**Re: North American Electric Reliability Corporation  
Docket No. RM\_\_ - \_\_ - \_\_  
Petition of the North American Electric Reliability Corporation for Approval of a  
Revised Definition of “Bulk Electric System” in the NERC Glossary of Terms  
Used in Reliability Standards**

**PETITION OF THE  
NORTH AMERICAN ELECTRIC RELIABILITY CORPORATION  
FOR APPROVAL OF A REVISED DEFINITION OF “BULK ELECTRIC SYSTEM”  
IN THE NERC GLOSSARY OF TERMS USED IN RELIABILITY STANDARDS**

Figure 1 (Inclusion I1):

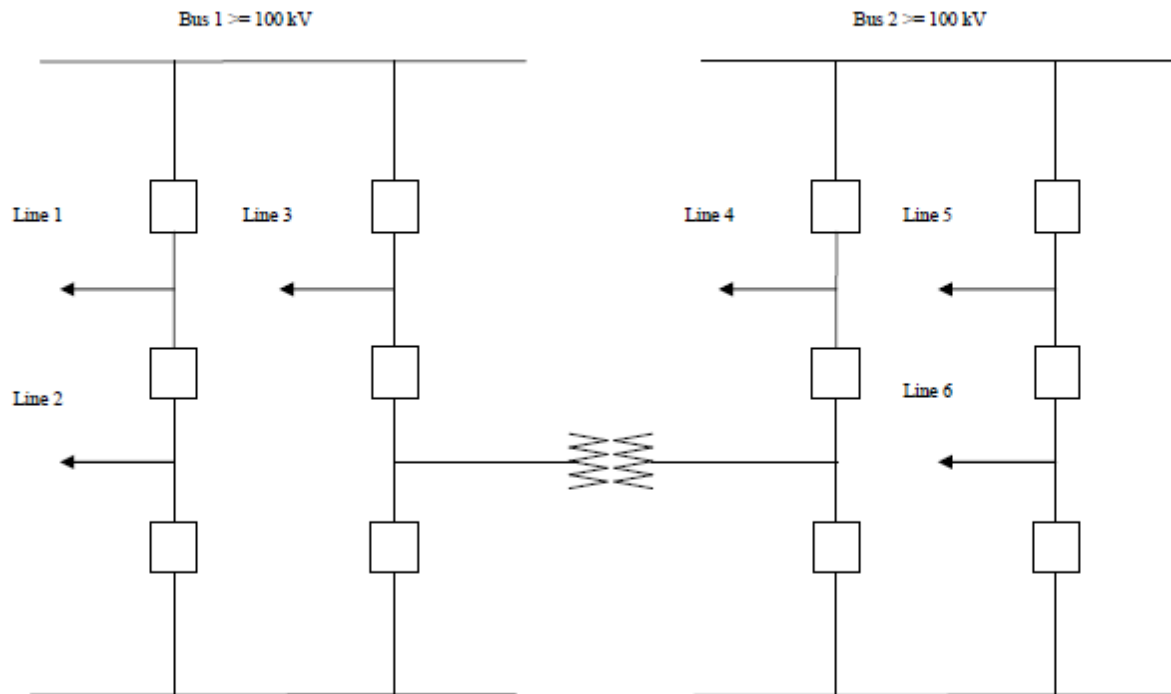
**Rochester Diagrams:** These diagrams were supplied by Rochester as examples and do not reflect the SDT's opinion of what is and isn't a BES Element.
